TELOPEA CONCEPT PLAN AND STAGE 1A

Response to Request for
Further Information
SSD-14378717

Prepared for
FRASERS PROPERTY TELOPEA DEVELOPER PTY LTD
December 2022

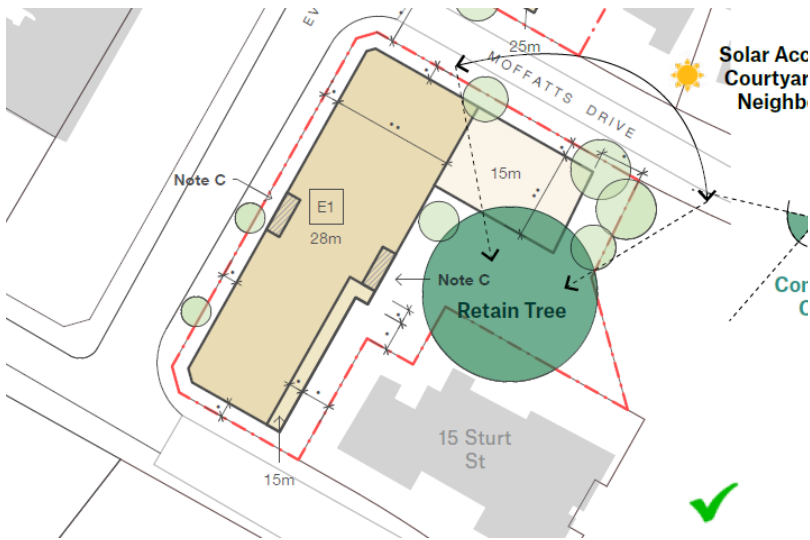
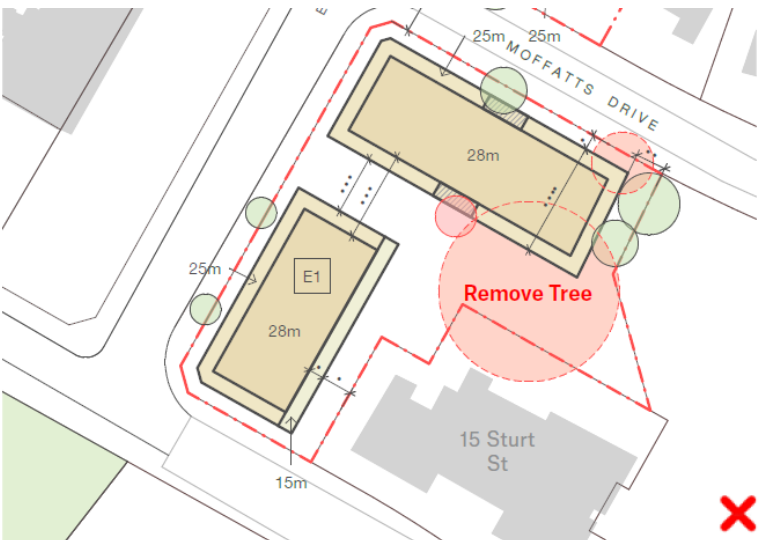
Comment	Response	Supporting Documentation
<ul style="list-style-type: none"> Amend the Design Guidelines to reference the Apartment Design Guide. Amend the Design Guidelines to clearly identify what provisions apply to the Core, the Precincts, or both. Update the terminology in the Design Guidelines to refer to the Core and Precincts. Amend the Concept and Stage 1A design drawings to be consistent with the recommendations outlined in Attachment B. 	<p>This provision applies to all precincts, apart from the upper core, where tower buildings are setback from de-scaled podiums of 12-25 metres in height, which is appropriate to manage the scale of the tower forms on the public domain.</p> <ul style="list-style-type: none"> Provision 1.1 (6) - The Department recommended that development of 7 and 8 storeys shall provide a 6 storey street wall and provide one upper level setback 3 metres from the building line (for 7 storey developments) or two upper level storey setback 6 metres from the building line (for 8 storeys). The majority of the buildings comply with the feedback received. <p>In the North Precinct, three buildings have an 8 storey height limit (N3, N6 and N8). Due to the site's curved streetscapes and orientation, concept building envelope depths are 22.5m with a 21.5 building depth proposed for the reference design to maximise solar access and amenity. The requested 6m setback to the upper two storeys would result in a 15.5m building depth which is highly inefficient and would result in a 3.5 metre width for apartments on Levels 7 and 8. An alternative 7 storey street wall is proposed for all three buildings with a single storey upper level setback 3m from the building line. Refer to Figure 4.</p> <ul style="list-style-type: none"> Provisions 1.1 (3&4) – Tower setbacks in the upper core area generally adopt a minimum 3 metre setback from the street wall. Inclusion of provision 4 to allow tower setbacks to reduce to 0m is provided where significant existing trees have been retained. Provision 1.1 (7) – In the precincts, developments are to have a minimum side setback of 3 metres and 6 metres where habitable rooms face the side boundary. Zero side boundary

Comment	Response	Supporting Documentation
	<p>setbacks have been provided to neighbouring sites, where a better amenity outcome is achieved.</p> <ul style="list-style-type: none"> • Recommended new provision – Rear setbacks in the Precincts should be a minimum 10m / 15% of the total length of the site. This recommended new provision has not been adopted for the Precincts. Analysis by Bates Smart has demonstrated a consistent 10m deep or 15% site length rear setback does not consider a precinct wide tree retention strategy. The North and South precincts priorities the retention of significant trees and achieves compliant deep soil landscaping DCP requirements. • Provision 1.6 – 5% of market dwellings incorporate the adaptable housing requirements of AS4299 Class C. The provisions also require 90% of social dwellings should incorporate the Liveable Housing Guideline's silver level universal design features, with the remaining 10% of all social housing dwellings incorporating the Liveable Housing Guidelines' Gold level universal design features. • New provision 2.2 (7) – The new provision recommending Precinct Public Domain Plans be prepared before the next DA or any Design Competition has not been included in the updated Design Guidelines. Public Domain Plans for each precinct have been prepared for this Concept DA and referenced in the Design Guidelines and Design Excellence Strategy. The Public Domain Plan for the Concept Proposal addresses the matters listed in the recommended new provision, as follows:

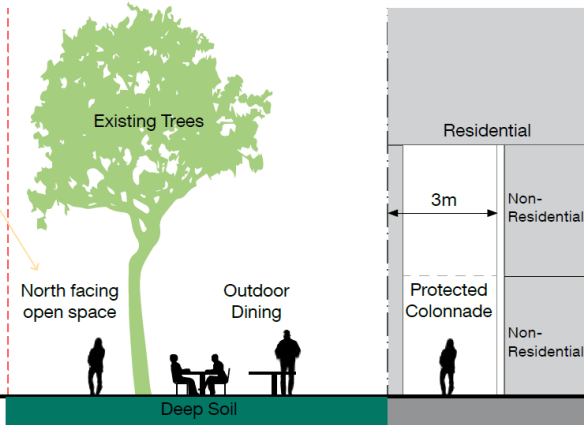
3.2 That 21 Sturt Street and the proposed ‘land swap’ be removed from the VPA letter of offer.	In relation to 21 Sturt Street CoP has now received written confirmation on 29 March 2022 from LAHC advising CoP that it “supports the compulsory acquisition of 21 Sturt Street, Telopea, as part of the Telopea Urban Renewal Project.” CoP maintains that the property shall not form part of the VPA and be removed from the Letter of Offer.	<p>Consistent with the Revised Letter of Offer made to Council, dated 9 November 2021 and subsequent discussions with Council Officers, 21 Sturt Street has been removed from the VPA Offer. Transfer of the land at 21 Sturt Street and Council owned roads is proposed via compulsory acquisition between Council and LAHC, provided the parties can reach an agreement under Section 30 of the Land Acquisition (Just Terms Compensation) Act 1991 (LA Act).</p> <p>Agreeing to the terms of a Section 30 agreement to transfer the 21 Sturt Street land and Council owned roads to LAHC will be a condition precedent</p>

Council Submission (November 2021)	Council Comment (June 2022)	Response	Supporting Documentation
		to the delivery of the other developer contributions under the Local VPA.

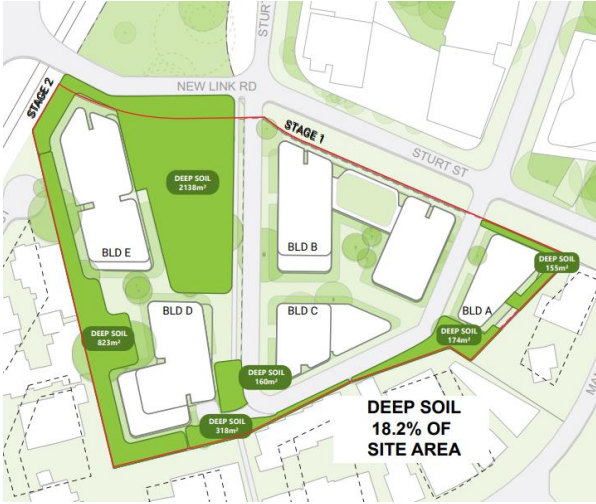
Council Submission (November 2021)	Council Comment (June 2022)	Response	Supporting Documentation
<p>4.2 That the applicant revise the design of the Precincts consistent with the Telopea DCP.</p>	<p>CoP recommends the Precincts should be delivered in accordance with the controls contained in the Parramatta DCP for the Telopea Precinct to achieve consistency across the precinct. Refer Attachment B for specific commentary on the Design Guidelines and additional site testing in the Precinct.</p> <p>Recommended key design amendments / design controls:</p> <ul style="list-style-type: none"> ▪ Street wall heights – Provide a maximum 6 storey street wall, and a 3m or 6m setback for the upper levels of a 7 or 8 storey building respectively. ▪ The 0m side setbacks result in excessive façade lengths. While some articulation zones have been included on building envelopes in the Precinct, there are several facades that still reach between 70-100m. Such long facades may lead to issues of excessive excavation and large retaining walls, as well as impact the desired finer grain resolution for the streetscape. ▪ The proposed development of isolated lots via party walls with LAHC development will also needs to be considered, as these developments could create building lengths of up to 65m. ▪ Front setbacks – New development must provide a 6m setback to the street to align with the existing streetscape, increase deep soil zone (DSZ) and improve amenity for residents. 	<p><u>Street wall heights</u></p> <p>Podium and tower typologies were never envisaged for the entire core area. The lower core was defined by streetwall typologies with a lower scale of 6 storeys and an upper scale of 6 storeys.</p> <p>The proposed envelopes propose a combination of streetwall buildings with and without upper level setbacks, committing to diversity of streetwall heights to create a diverse range of architectural character and improve solar access and residential amenity.</p> <p><u>Front setbacks</u></p> <p>As noted in Section 3.1.1 and the Concept Architectural Plans prepared by Bates Smart, the North and South Precinct, have been increased from 3 to 4 metres.</p> <p><u>Side setbacks</u></p> <p>As noted in Section 3.1.1 and the Concept Architectural Plans prepared by Bates Smart, building articulation zones have been introduced to reduce the length of façades. Increased setbacks have also been provided adjacent to potential isolated lots to encourage increased deep soil areas in the future.</p>	<p>Appendix B Concept Proposal Drawings</p> <p>Appendix C Concept Response to Submissions Report</p>

Council Submission (November 2021)	Council Comment (June 2022)	Response	Supporting Documentation
	<ul style="list-style-type: none"> Side setbacks – A minimum 3m setback to the side boundaries for part of the length of the building, increased to 6m where habitable rooms only face the side boundary. Rear setbacks – A rear setback of 15% of the site length or 10m (whichever is greater) to allow for larger portions of uninterrupted DSZ of a reasonable width and depth. This will allow a continuous deep soil network formed with adjacent lots. Deep Soil Zones (DSZ) – Provide a minimum 30% of DSZ on the site area, with half of the total deep soil area located at the rear of the site. Minimum dimensions for area to be considered as deep soil are 4m x 4m as per the Parramatta DCP and 6m x 6m as per the ADG. Deep Soil area and basement plans showing all proposed basement outlines aligned to recommended front and rear setbacks and remaining deep soil on private land only and not under proposed roads. 	<p><u>Rear setbacks</u></p> <p>As noted in Section 3.1.1 and the Concept Response to Submissions Report prepared by Bates Smart, while deep soil is generally located within rear setbacks as noted in the Telopea DCP, the proposed concept generally encourages a stepped form, forming smaller courtyards rather than one large continuous 10 metre deep soil zone to rear boundaries. The overall deep soil approach maintains the minimum DCP quantitative requirements (30%) but have been delivered in a slightly different format with consideration of significant clusters of existing substantial trees across the site.</p> <p><u>Deep soil zones</u></p> <p>As noted in Section 3.1.1 and the Concept Response to Submissions Report prepared by Bates Smart, a minimum of 30% deep soil has been achieved across the site. Basements are setback from street frontages to maximise deep soil opportunities to street.</p> <p>The Concept Response to Submissions Report prepared by Bates Smart includes measurements of deep soil landscaping calculated for the DCP requirement of minimum 4mx4m dimensions and ADG minimum dimensions of >6m.</p> <p>Whilst not strictly in accordance with the minimum 10m deep or 15% sit length rear setback controls,</p>
